**Statement of Compliance  
Access for People with a Disability**

**Proposed Mixed Use  
Development**

1 Bilambee Ave Bilgola Plateau

**Report Type:** Statement of Compliance - BCA Access Provisions  
**Development:** 1 Bilambree Ave Bilgola Plateau

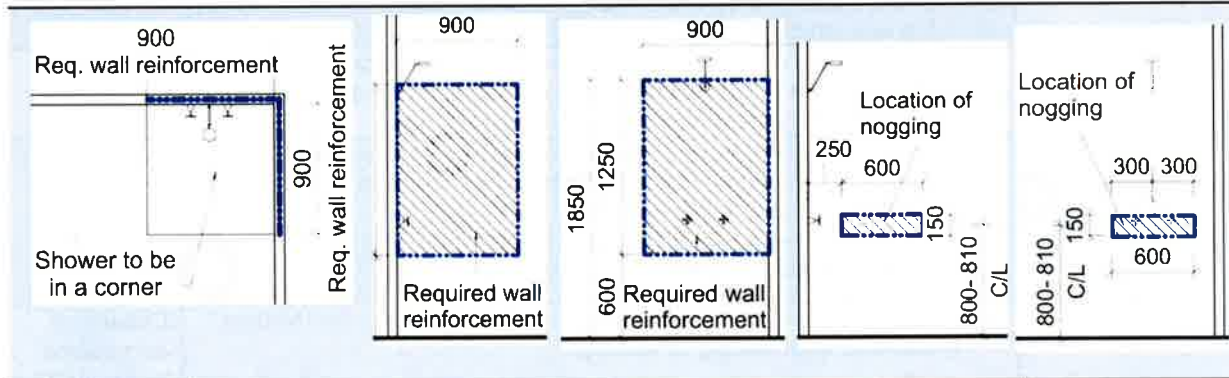
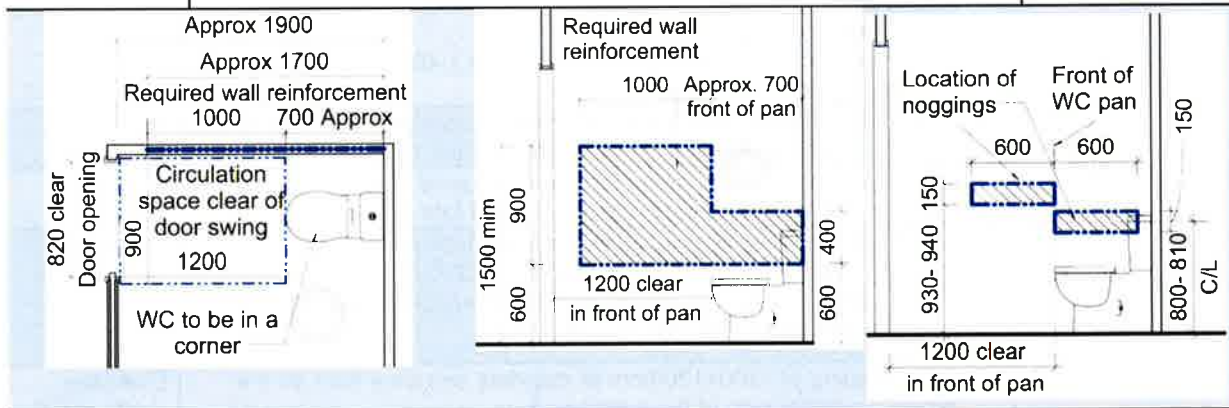
Unit 105 is capable of providing compliance with the features of Silver level of Livable Housing Guidelines as noted in the table below.

By incorporating the requirements of the below Checklist in the Specifications of the project, the nominated Livable units can achieve full compliance with Livable Housing Guidelines- Silver Level
